SALEM NUCLEAR GENERATING STATION, UNIT NO. 2

Amendment No. 47  
License No. DPR-75

ATTACHMENT TO LICENSE AMENDMENT NO. 47

SAFETY EVALUATION BY THE OFFICE OF NUCLEAR REACTOR REGULATION  
RELATED TO AMENDMENT NO. 47 TO FACILITY OPERATING LICENSE NO. DPR-75

**Figure 3.4-2 Salem Unit 2 Reactor Coolant System Heatup Limitations  
Applicable Up to 7 EFPY**

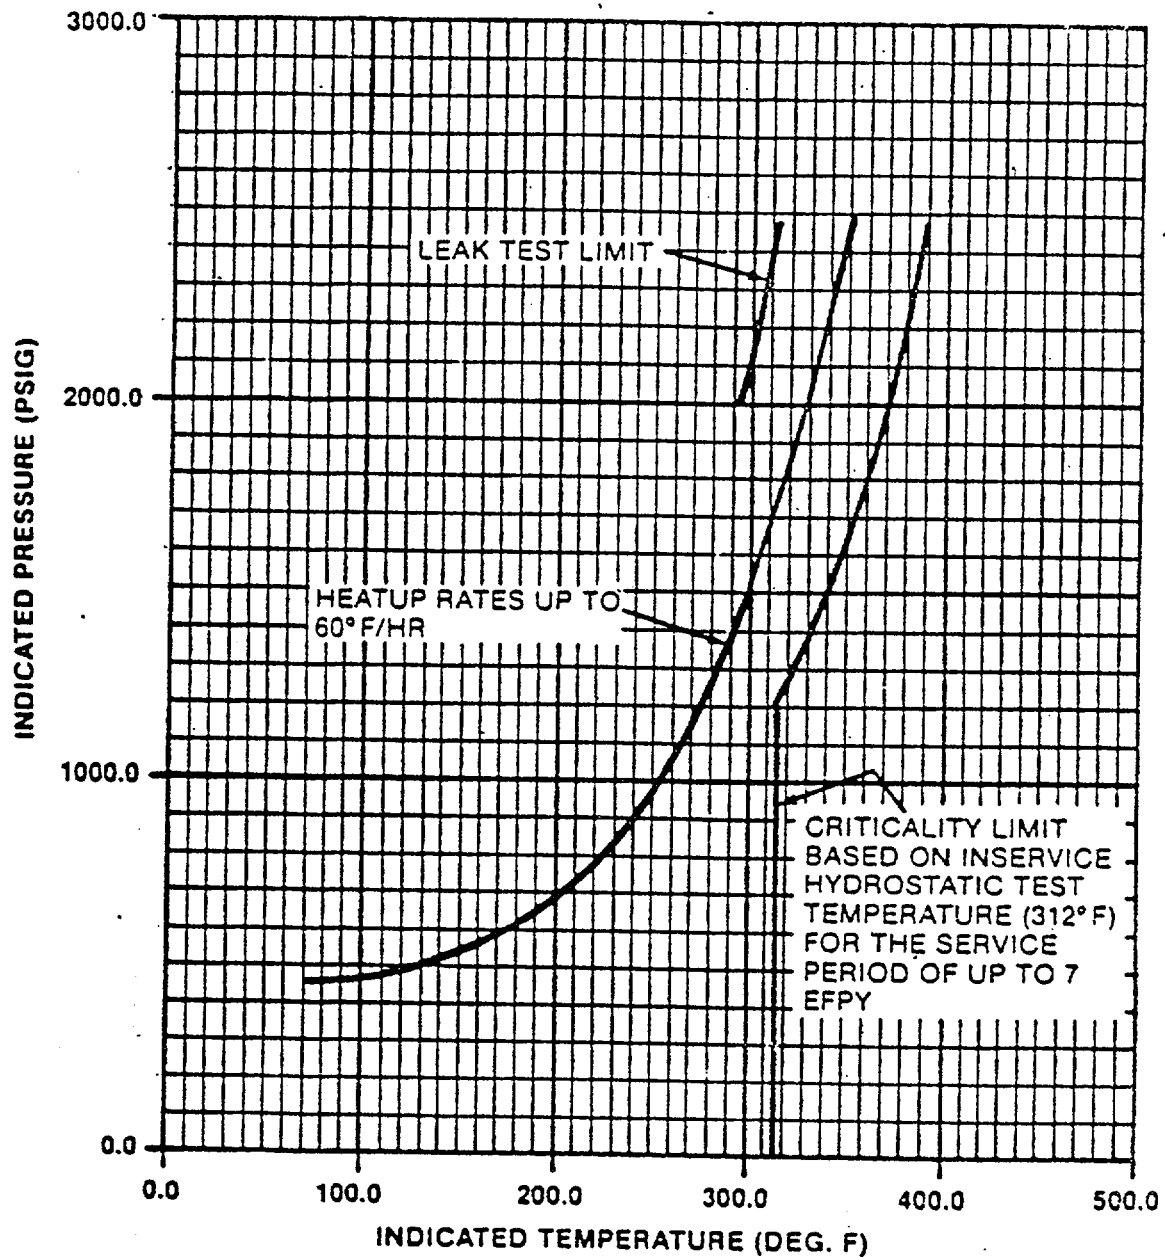
The amendment revises the Heatup Limits Curve and the Cooldown Limits Curve for Unit No. 2.

In a letter from E. A. Liden to S. A. Varga dated October 15, 1984, the Public Service Electric & Gas Company (the licensee) proposed an amendment to their Facility Operating License DPR-75 for Salem Generating Station, Unit No. 2 (Salem-2). The amendment proposes to revise heatup and cooldown limit curves in Figures 3.4-2 and 3.4-3, and bases Figure B 3/4.4-1 in Appendix A of the Salem-2 Technical Specification. The revised curves are to be applicable through seven (7) effective full power years (EFPY). The bases for these changes are the test results from the Salem-2 surveillance program, which are contained in Report WCAP 10492, "Analysis of Capsule T, Salem Unit 2 Reactor Vessel", dated March 1984. Report WCAP 10492 was submitted for staff review in a letter from E. A. Liden to S. A. Varga dated July 3, 1984.

The staff has used the method of calculating pressure-temperature limits in USNRC Standard Review Plan 5.3.2, NUREG-0800, Rev. 1, July 1981 to evaluate the proposed pressure-temperature limits. The amounts of neutron irradiation damage was calculated using design basis calculated neutron fluences and the Regulatory Guide 1.99, Rev. 1 upper limit prediction curve. Our conclusion is that the proposed pressure-temperature limits meet the safety margins of Appendix G, 10 CFR 50 for 7 EFY and may be incorporated into the plant's technical specifications.
